Date: July 24, 2023
To: Eric Schneider
From: Jason Brûlé
Subject: Zoning By-law Amendment and Official Plan Amendment Application
Ideal Capital Limited
93-99 Benton Street and 39-43 St. George Street, Kitchener
ZBA 23/012/B/ES
OPA 23/008/B/ES

**Re: Proposed Official Plan Amendment OPA 23/08 and
Zoning By-law Amendment ZBA 23/012
93-99 Benton Street and 39-43 St. George Street
MHBC Planning Inc. (C/O Trevor Hawkins and Julianne
von Westerholt) on behalf of Ideal Capital Limited (C/O
Daljeet Dhanesar)
CITY OF KITCHENER**

Project Address: 93-99 Benton Street/39-43 St. George Street

File Number: OPA23/008/B/ES & ZBA23/012/B/ES

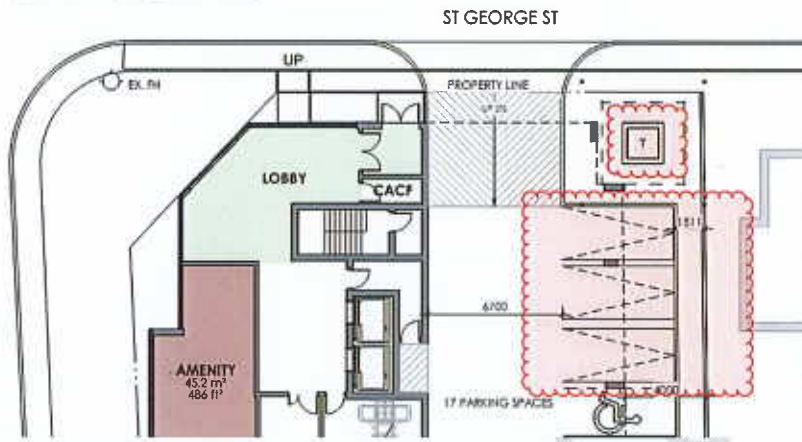
- The tower should step back from its base a **minimum of 3m** along any street-facing elevations.
- The proposed podium along Benton Street should be broken down using enhanced detailing and articulation.
- The tower should be situated in a location that makes an effort to maximize views from the adjacent properties and the streetscape. The proposal will benefit from additional setbacks/step-backs and shifts in volume to create enhanced views and stepped terraces. This will help transition to the adjacent neighborhood and benefit sky views, sun/shadow and microclimate. Please see attached precedent images.
